Lovely Addition

Moonn Electronics

Mostly the fuzz of an old Fender fuzz wah

Fixing the Mistake

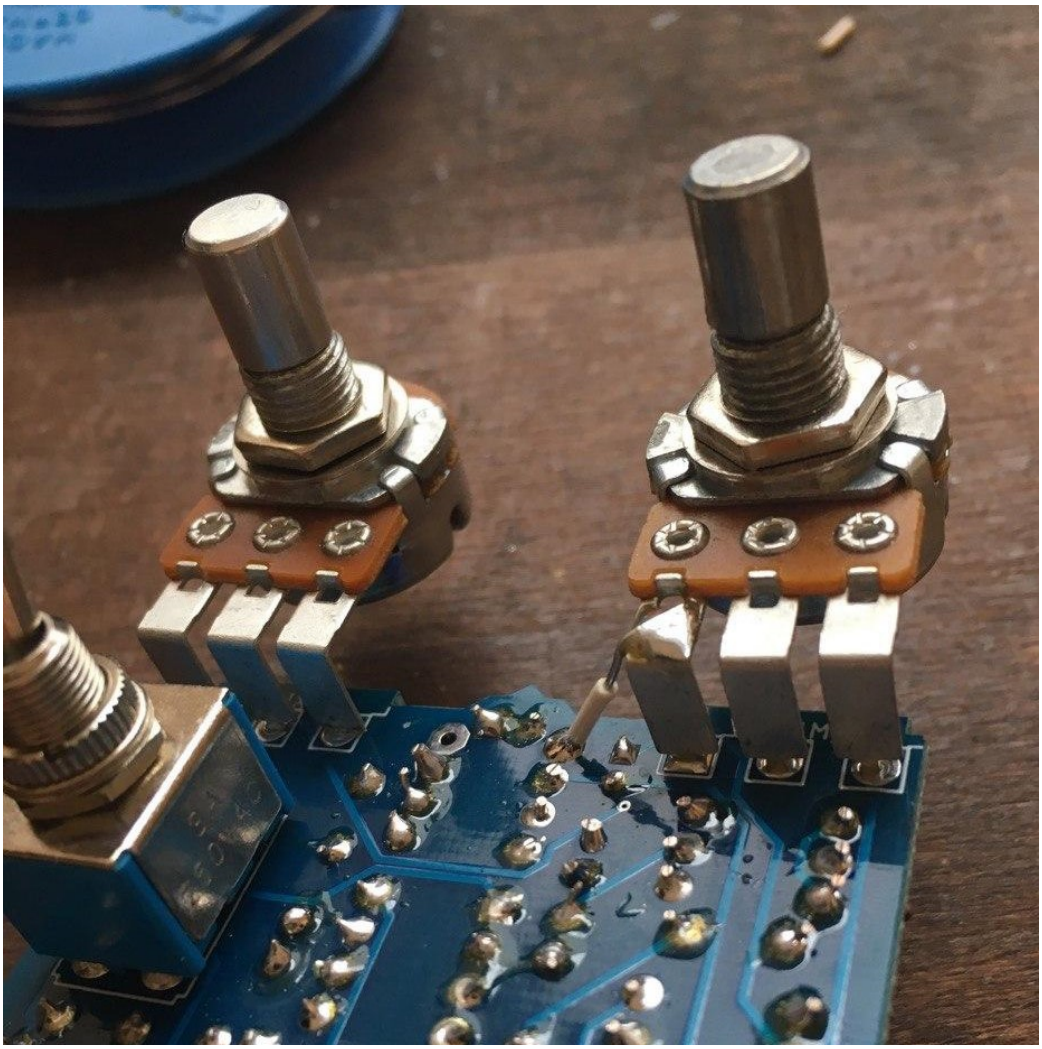
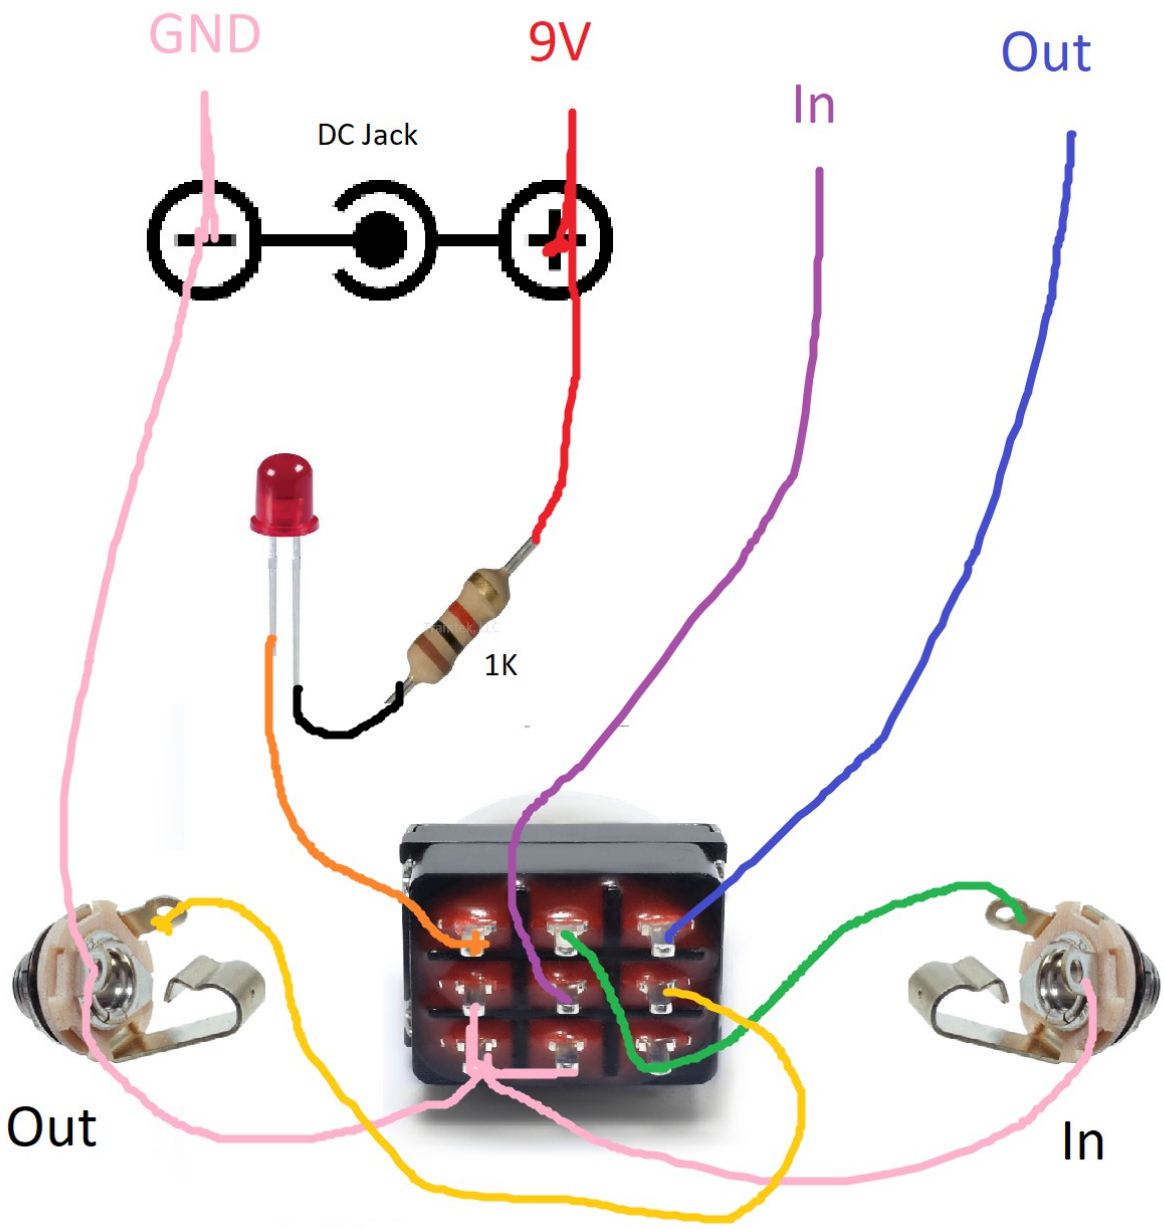
The person who designed me made a stupid mistake so you will have to solder a extra wire to fix that.
The picture below (Page 4) will show you what to do. (Don't worry its easy)

Just solder a wire from lug 1 of the volume pot to the pad labled „-“.
